중앙 원형 팝업 수정안 / 전체 조립

예비 수정안 / 구매 팝업 규격 미선정 / 실측 및 시험 전 제작 확정 금지

01_Frame_With_Integral_Round_Pad

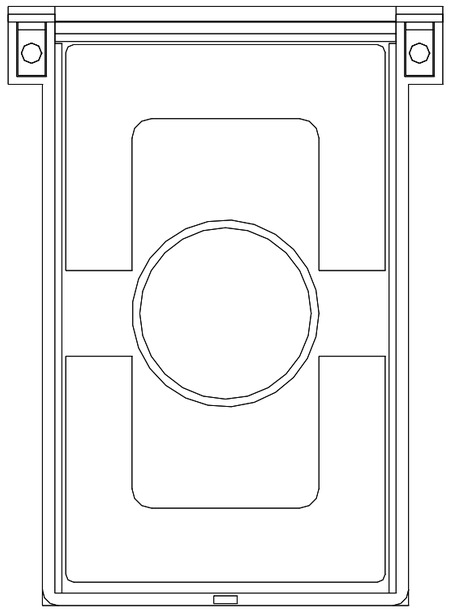
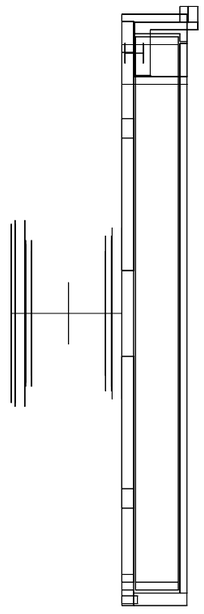
Old link arms, hinge pins, index pins REMOVED

Magnetic gate and mechanical shoulders retained

Popup is a purchased - part ENVELOPE, not a printed spring

Integral frame mounting pad D44 x2.5

Phone adhesive base D48 x2.5

Purchased popup: upper D40 / lower D38 ASSUMED

Folded 31.9 / open 47.9 mm incl. gate

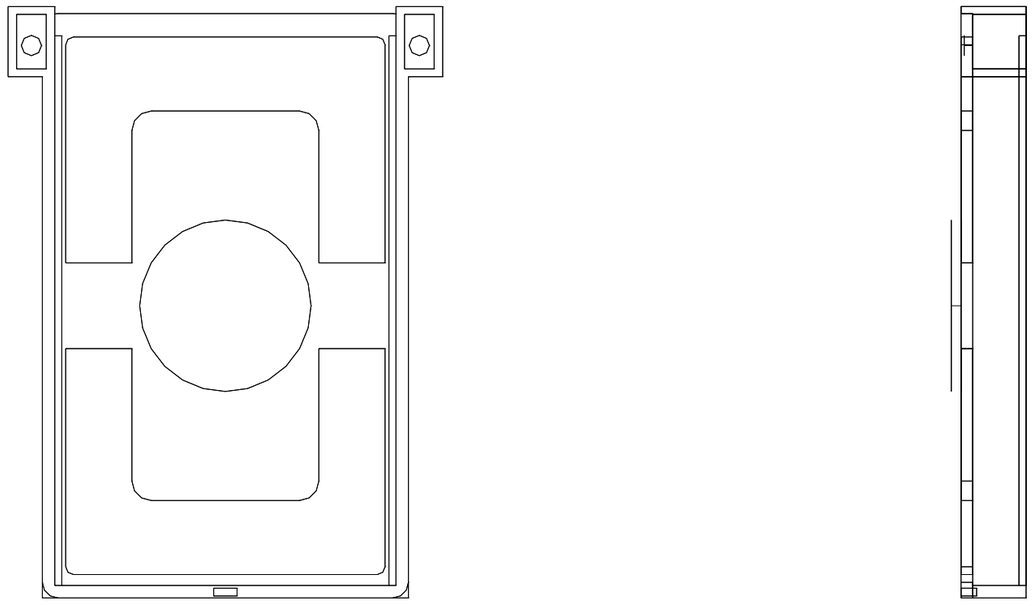
Obsolete four M3 mount holes filled; NO link bracket

No printed OEM bellows STL in this release

Part01 integral rear pad D44, Z - 2.5..0
